**Sudbury-Hudson Transmission Reliability and Mass Central Rail Trail Project**

**Vernal Pool Buffers  
Sudbury, Massachusetts**

Wetland Impact Area	BETA Comments from Table 1 (Table 1 - 8/7/2020)	Applicants' Response to BETA Comment	BETA Recommendations (Table 1 - 8/7/2020)	Applicants' Response to Recommendations	No Adverse Effect Conclusion
S1	<ol style="list-style-type: none"> <li>1. Work site, removal of ground cover/brush piles and resulting bike path will restrict movement between vernal pool and neighboring wetland where amphibians will seek cover in late summer through early winter.</li> <li>2. Proposed restoration includes herbaceous cover in seed mix but does not include replacing woody debris with brush piles.</li> <li>3. Large Woody Debris habitat not listed on Field data form but appear in photo log.</li> <li>4. Restoration includes planting of low-bush blueberry.</li> </ol>	<ol style="list-style-type: none"> <li>1. The Project will not restrict movement to/from the vernal pool. VP1 is 75 feet from proposed limits of work for project. See BETA comment for S2. 94.3% of suitable habitat within the 100 ft. VP Buffer will remain. Removal of the rails and ties improves co

**APPROX. PRESUMED VERNAL POOL 1**  
 VP Status: Presumed  
 Closest Distance to Work: 75 LF  
 Total 100ft BZ: 40,421 SF  
 Previously Disturbed: 3,257 SF  
 Existing Suitable Habitat: 37,164 SF  
 Proposed Permanent Impact: 885 SF  
 Remaining Suitable Habitat: 35,052 SF (94.3%)

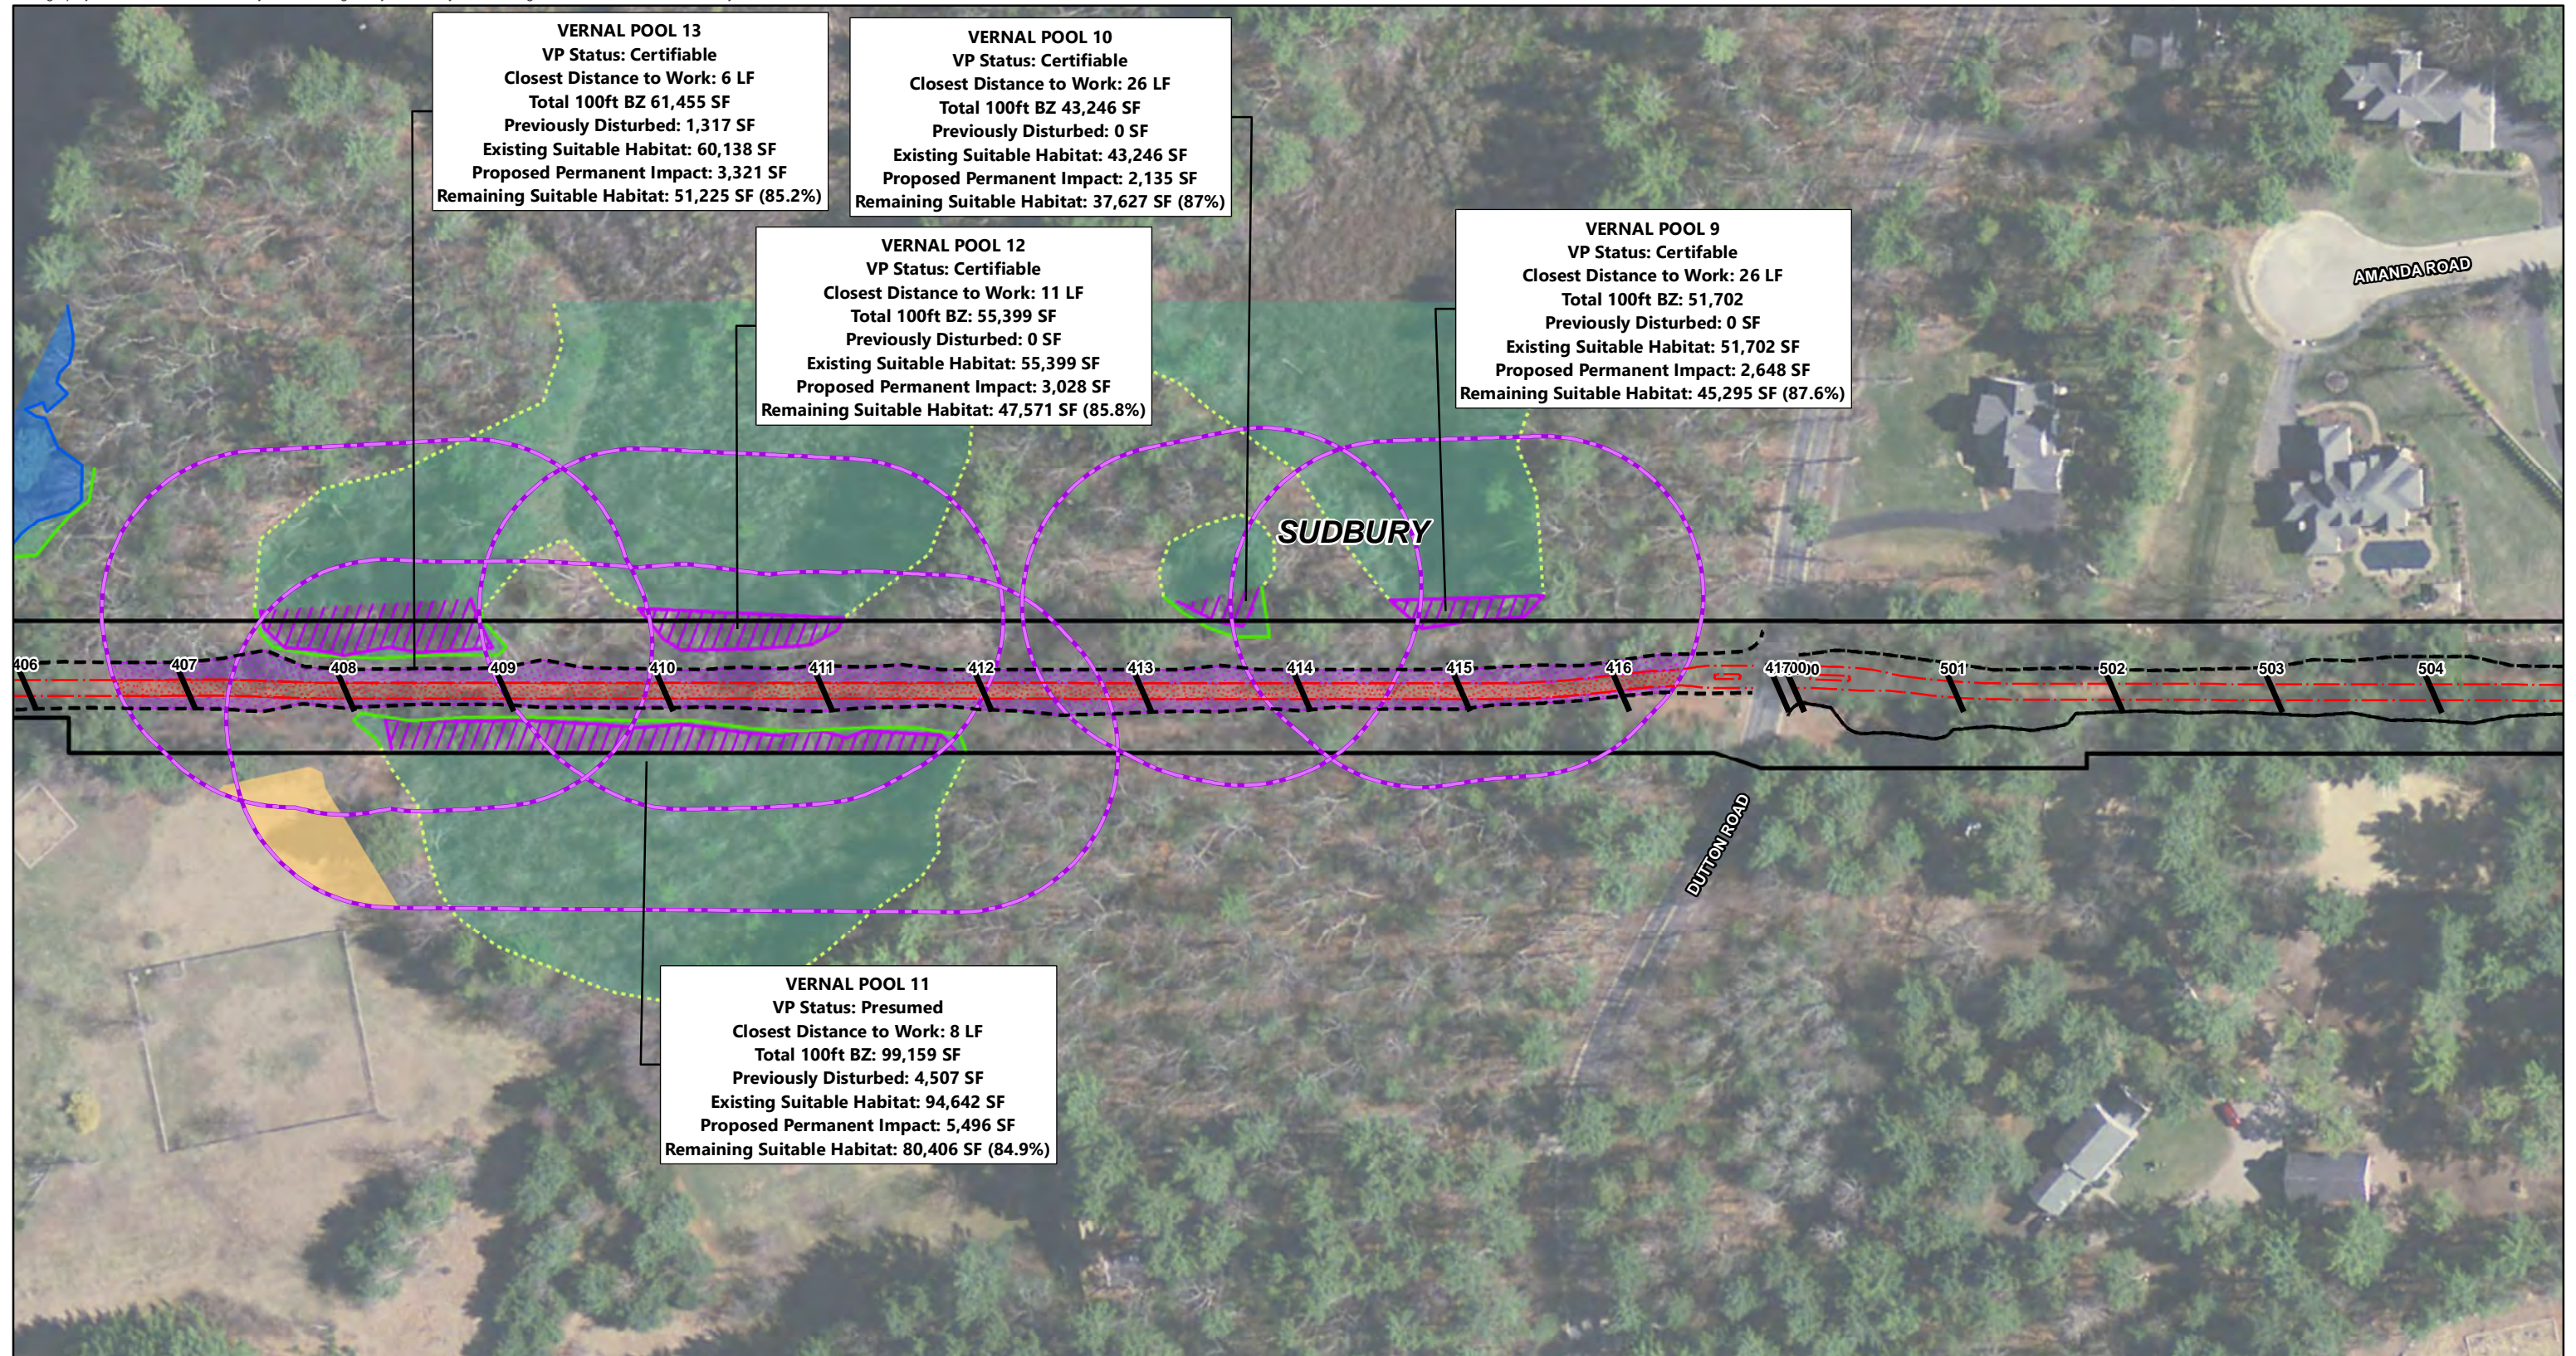
**APPROX. PRESUMED VERNAL POOL 2**  
 VP Status: Presumed  
 Closest Distance to Work: 70 LF  
 Total 100ft BZ: 39,130 SF  
 Previously Disturbed: 3,618 SF  
 Existing Suitable Habitat: 35,512 SF  
 Proposed Permanent Impact: 1,255 SF  
 Remaining Suitable Habitat: 32,259 SF (90.8%)
